## Submission on VNI West Project Assessment Draft Report

I wish to make a submission on the [Project Assessment Draft Report \(PADR\)](#) for the Victoria to New South Wales Interconnector West (VNI West), issued on 26 July 2022.

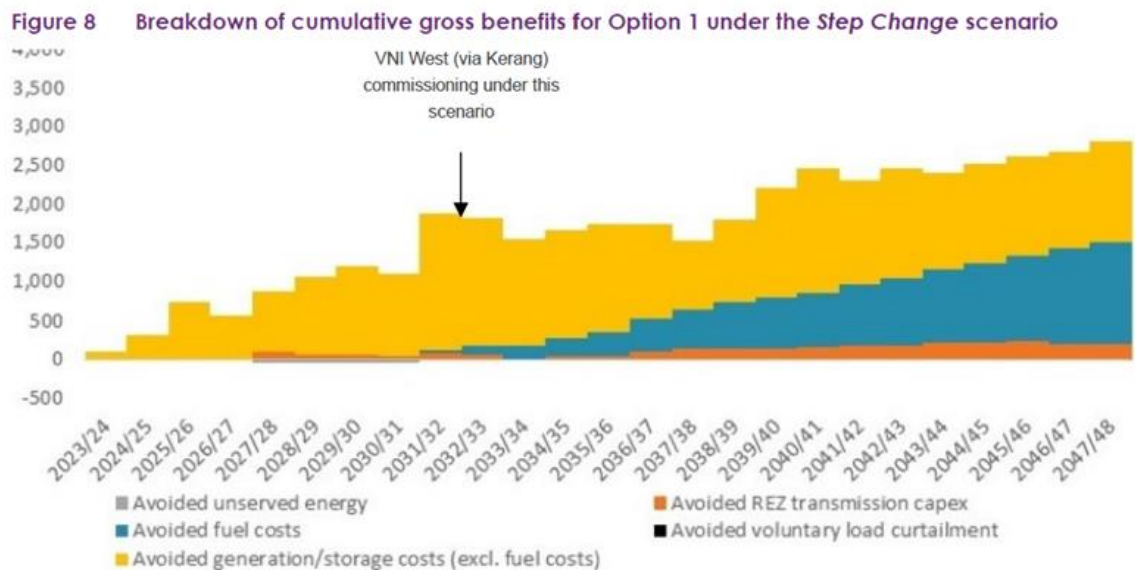
Without these aberrant assumptions there would be minimal benefits pre-commissioning, less benefits over the remainder of the 25-year modelling period, and negligible if any benefits thereafter.

The forecast net benefit of \$884m (Step Change scenario) appears to be based on seriously flawed assumptions. It is far more likely that the cost of VNI West will far exceed its benefits.

**Figure 8 Breakdown of cumulative gross benefits for Option 1 under the Step Change scenario**

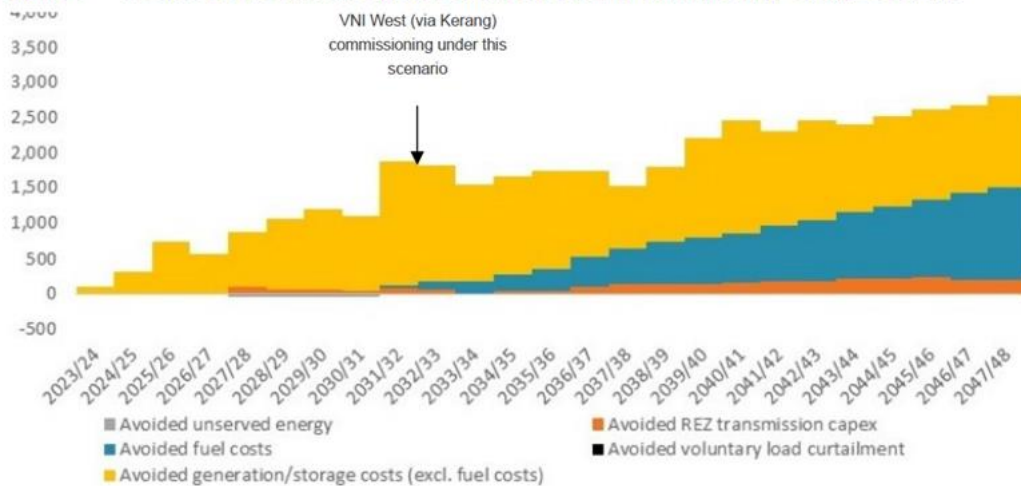
The forecast gross benefits for the Step Change scenario are conveniently displayed in Figure 8 of the PADR (extracted below for ease of reference – also see Attachment A).

The cumulative gross benefits from building VNI West are estimated to be \$2,795m by 2047-48, primarily from avoided generation/storage costs (\$1,295m) and avoided fuel costs (\$1,300m). A condensed extract from the VNI West PADR RIT-T NPV Model S1 is below.

Cumulative gross benefits pre-commissioning are estimated to be \$1,878m, almost entirely from avoided generation/storage costs.

Figure 8 indicates that VNI West will be commissioned at the end of 2031-32 under the Step Change Scenario. This submission assumes that is the date modelled in the PADR.

If, as I assumed, VNI West is commissioned at the end of 2031-32, Figure 8 indicates gross cumulative benefits at that time of \$1,878m.

These benefits, which have accumulated over nine years before VNI West starts operating, amount to twice the benefits that accrue in the following sixteen years when VNI West is actually in service and operating, of \$917m.

The modelling forecasts that VNI West accumulates twice the benefits when it is not operational compared to when it is, and in half the time.

**Figure 9 Difference in cumulative capacity build with Option 1, compared to the base case, under the Step Change scenario**

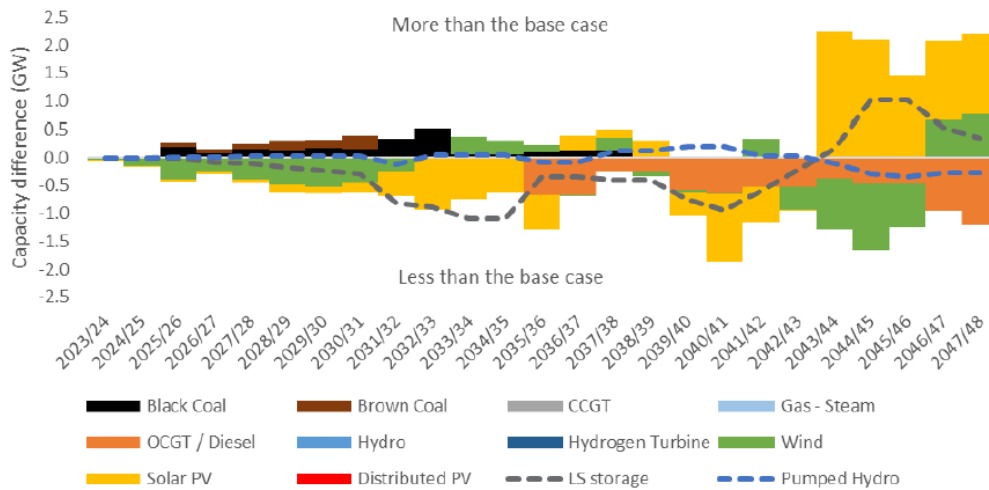
The PADR assumes up to 528 MW less wind (in 2029-30), 444 MW less solar (in 2031-32) and 807 MW less batteries (in 2031-32) - see Attachment B.

Solar capacity is projected to continue to be less than the base case up to 2035-36, in fact 921 MW less in 2032-33, resulting in 5 TWh less solar generation due to VNI West.

- solar capacity varies significantly year-on-year, depending on whether VNI West is built or not, for no apparent reason. For example, it is 921 MW less in 2032-33 and 1,199 MW less in 2040-41, but 2,245 more in 2043-44, ending at 1,440 MW more in 2047-48
